Migrating from FM20L08 to FM28V100

Author: Girija Chougala
Associated Project: No
Associated Part Family: FM20L08, FM28V100
Software Version: None
Related Documents: For a complete list, click here

AN109 discusses the key differences that need to be considered when migrating from FM20L08 to FM28V100. FM20L08 is now obsolete and this application note explains how FM28V100 is a replacement for FM20L08.

Figure 1. FM28V100 and FM20L08 Pin Assignments in 32-pin TSOP-I

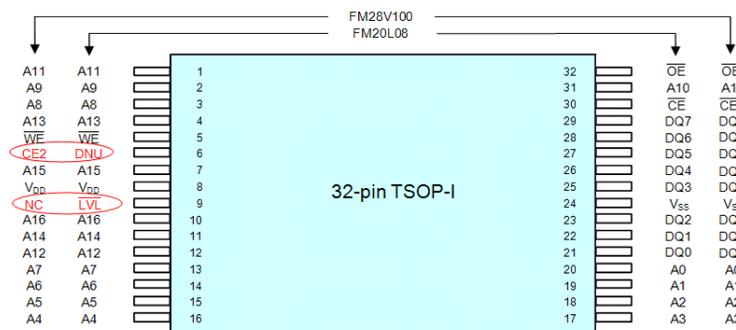
The two parts, FM20L08 and FM28V100 have differences at pin 6 and pin 9. The older part, FM20L08 has DNU on pin 6 and $\overline{LVL}$ on pin 9 while the FM28V100 has CE2 on pin 6 and NC on pin 9 as shown in Figure 1.

Pin 6: Since the pin is DNU on the FM20L08, there would be no connection on the PCB to pin 6. On the FM28V100, this pin is CE2 with an internal pull-up resistor. This ensures that CE2 is always enabled even without a PCB connection to the pin.

Pin 9: The $\overline{\text{LVL}}$ pin of the FM20L08 is an output pin. In the replacement part, FM28V100, pin 9 is NC. As most designs do not use the FM20L08 $\overline{\text{LVL}}$ pin, the pin would be left unconnected on the PCB and hence the FM28V100 can be a direct drop-in replacement with no PCB changes. In applications where $\overline{\text{LVL}}$ is used, it should be noted that $\overline{\text{LVL}}$ feature is not supported in the FM28V100. Also, since Pin 9 of FM28V100 is NC, the external circuitry will no longer be driven and hence it is recommended to add a pull-up resistor to pin 9.

Figure 2. Primary connections after migration

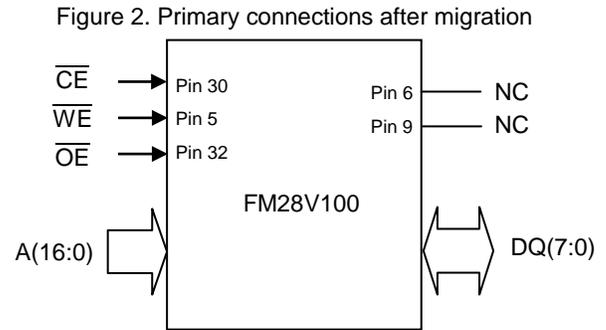
The primary connections after migration are shown in Figure 2. The active-low chip enable is $\overline{\text{CE}}$ on the FM20L08 and $\overline{\text{CE1}}$ on the FM28V100. Both are identical in functionality.
